**REQUEST FOR BIDS
FOR
CONSTRUCTION
FOR
CVAG OFFICES - TENANT IMPROVEMENTS PROJECT
PROJECT NO. CV-2026-TIP-01**

ADDENDUM

Addendum Date: May 20, 2026

**CVAG Offices – Tenant Improvements Project (TIP)
Project No. CV-2026-TIP-01**

Project Status
A2.21

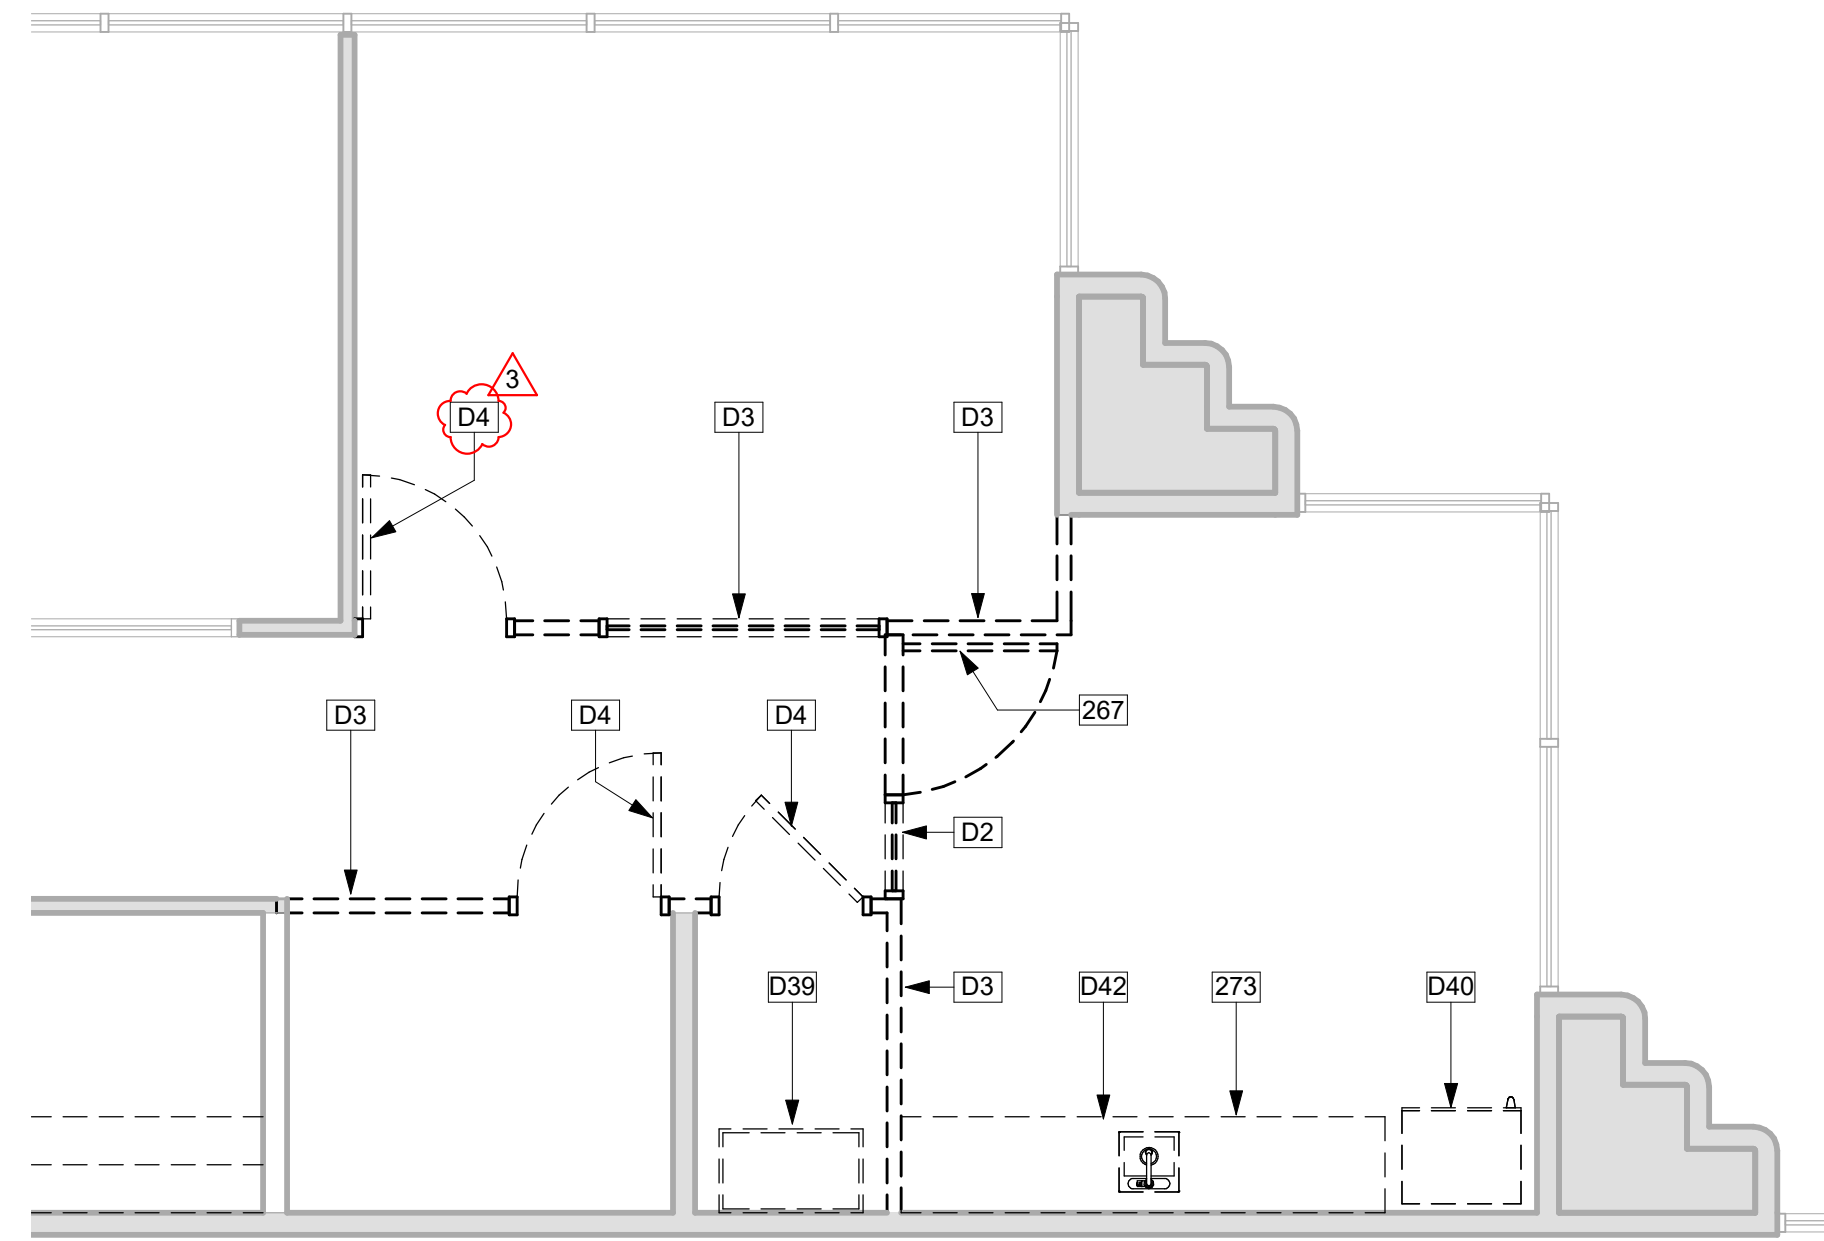
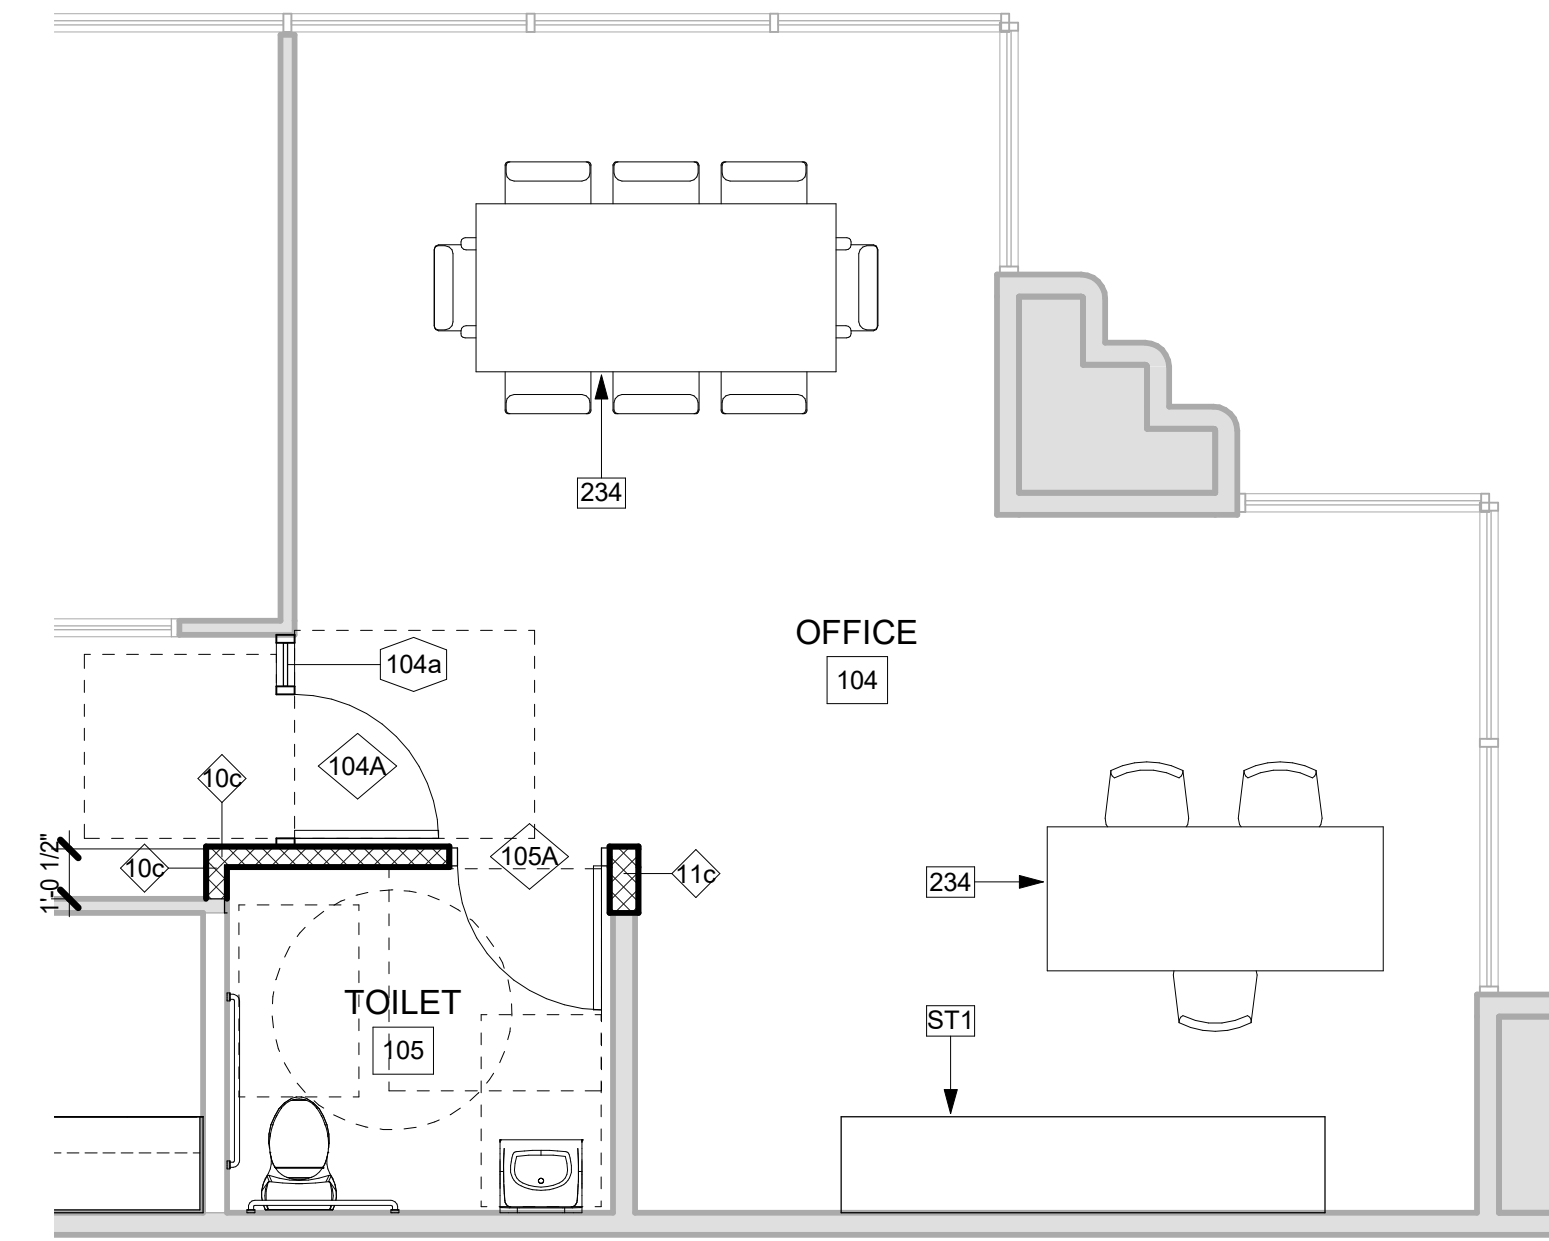
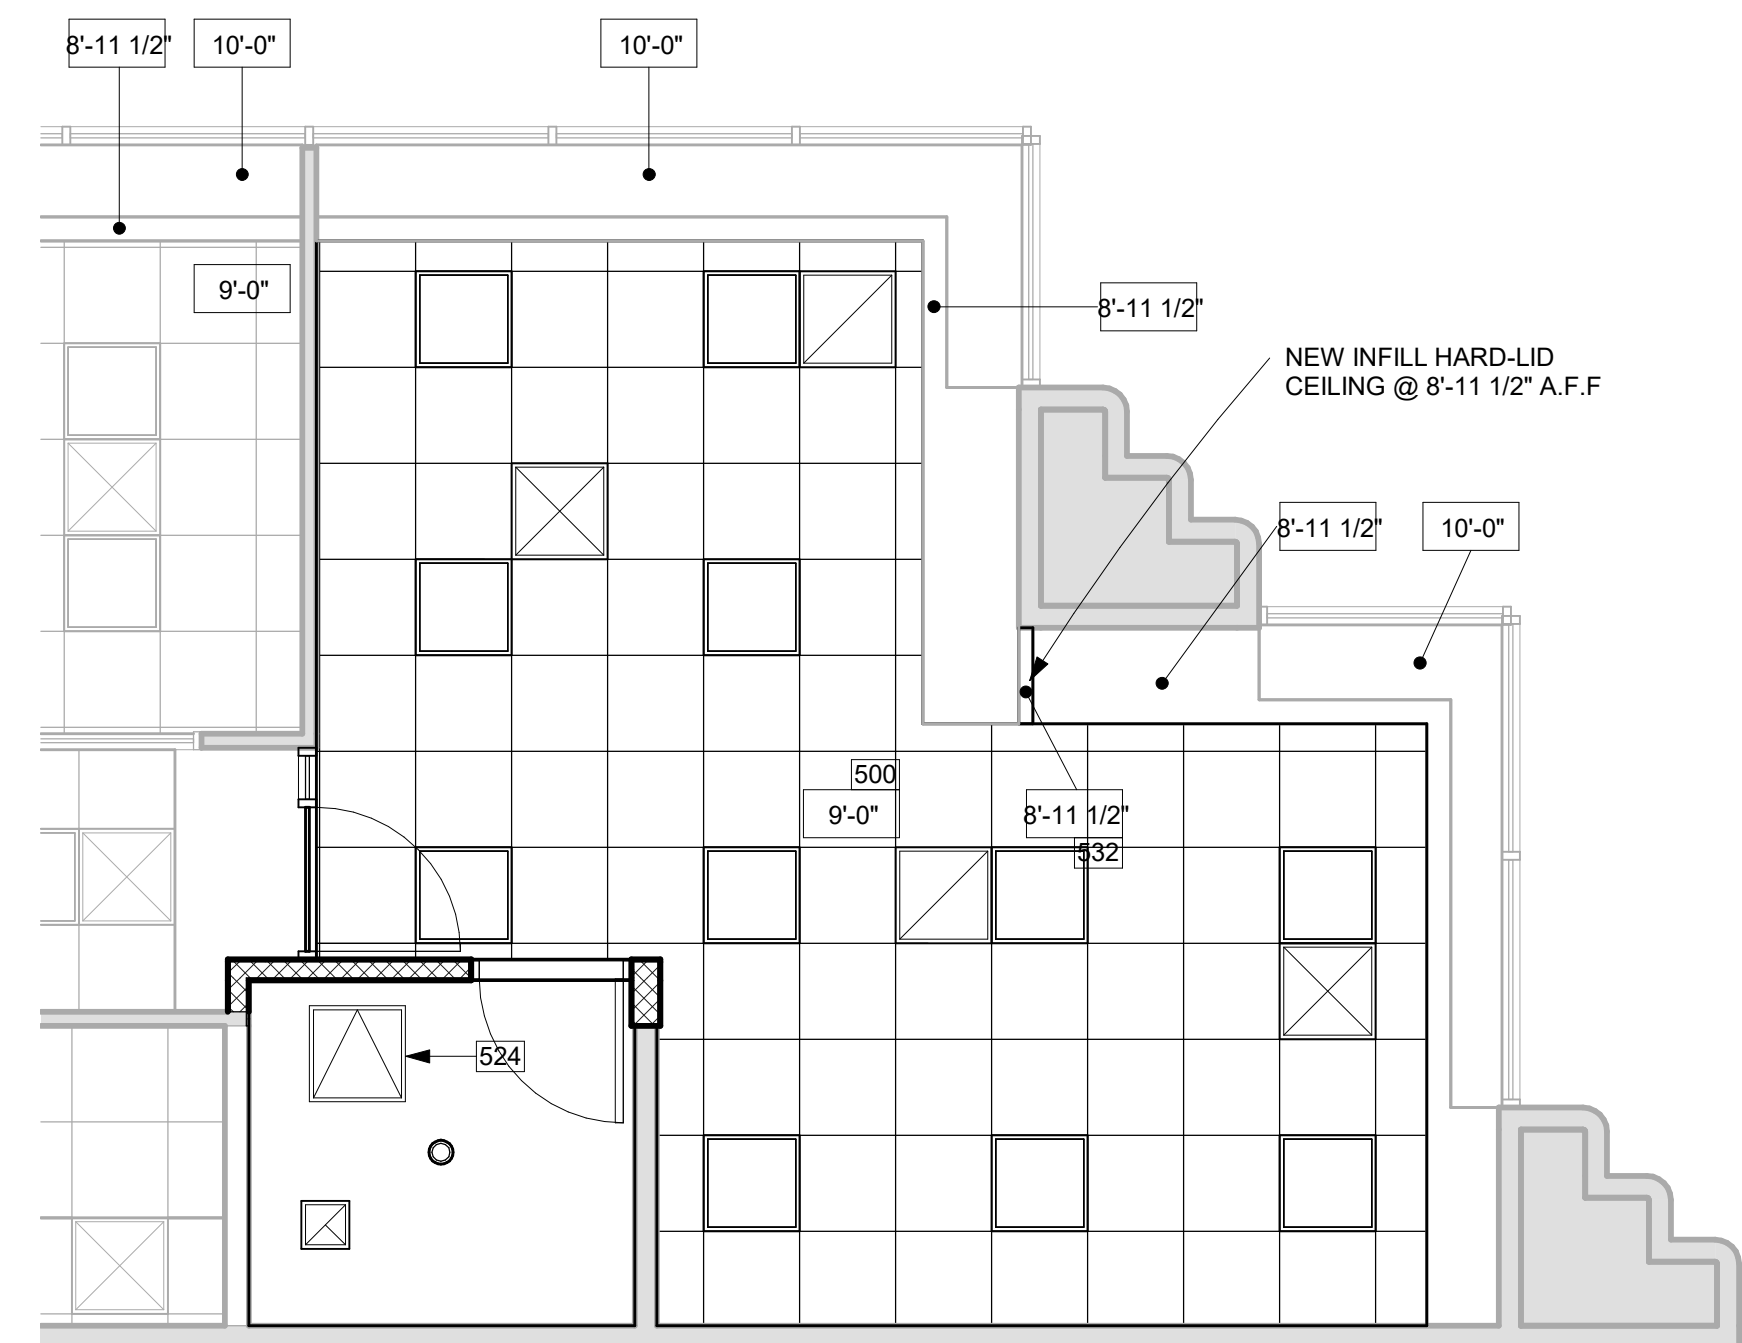
7. **Question:** Per plans, Phase 1 - Door 110A at the phone room is re-used from demo in Phase 2. Are they good with not having a door at the Phase 2 location during Phase 1? Please provide door trim finish specs.

25. **Question:** Keynote 524 identifies a 24 x 24 insulated/gasketed access panel. Please confirm quantity, exact location, and specifications for access panels.

Response: *Door 110A is no longer a reused door, it is now a new door. Reference Delta-3 on sheets A2.21, A2.24, & A7.10. Contractor to perform a site visit to verify door trim finish specs, as all new doors are to match existing.*

Response: *There is only one access panel in this project. It's location can be seen at 4/A2.21. The specification is called out in keynote 524 on sheet A2.21.*
